MEMORANDUM

DATE: 6 June 2024
TO: Development Determination Panel
CC: Steven Findlay, Manager Development Assessment
FROM: Kye Miles, Planner
SUBJECT: Item 3.4 - DA2023/0803 - 287 Mona Vale Road, Terrey Hills

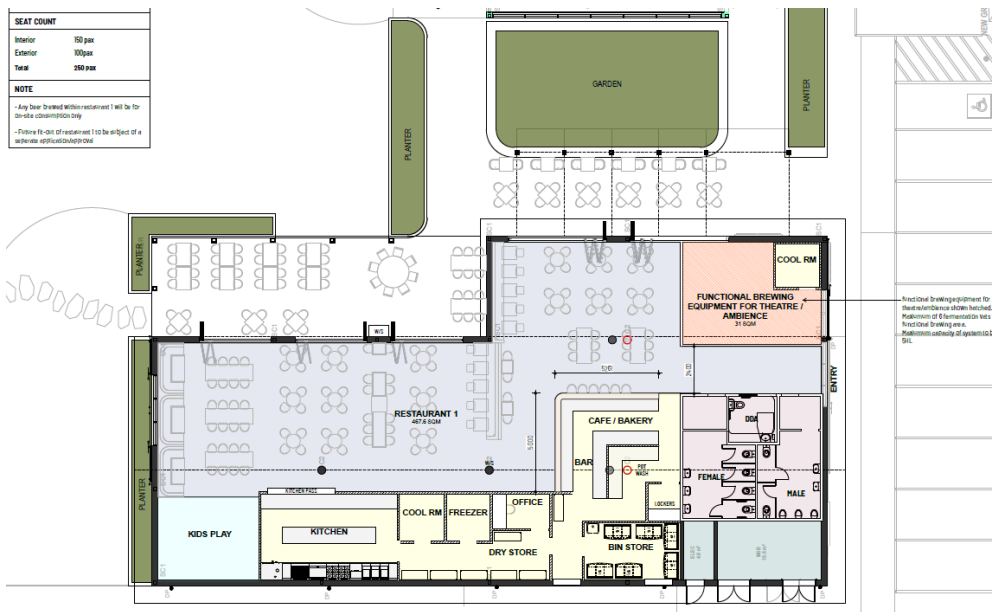
The applicant has submitted an amended floor plan for the proposed restaurant. An extract of this plan is provided below:

The plan specifies that the brewing component of the restaurant will be limited to the following:

- 5HL system maximum
- Maximum of 6 fermentation vats
- Have a maximum area within the Restaurant of 31sqm
- Any beer brewed within Restaurant 1 will be for on-site consumption only

The concern raised by the Panel was that the maximum brewing capacity sought aligns with that of comparable artisan food and drink industries, raising concerns about the ancillary function of this component. Additionally, artisan food and drink industries are not permissible within the RU4 Primary Production Small Lots zone.

Therefore, a further operational condition is recommended to ensure that the brewing component remains **ancillary** to the restaurant:

Ancillary Use

The brewing component shown on the approved plans, constituting 6.6% (31 sqm) of the total floor area of the restaurant, must remain ancillary to the restaurant's use. The brewing operations must be limited to the following:

- *Brewing production must not exceed 100 litres per week and is to be limited to one type of beer.*
- *Any beer brewed within Restaurant 1 must be for on-site consumption only and served in glassware.*

Reason: To ensure consistency with the permissible uses of the RU4 Primary Production Small Lots zone.
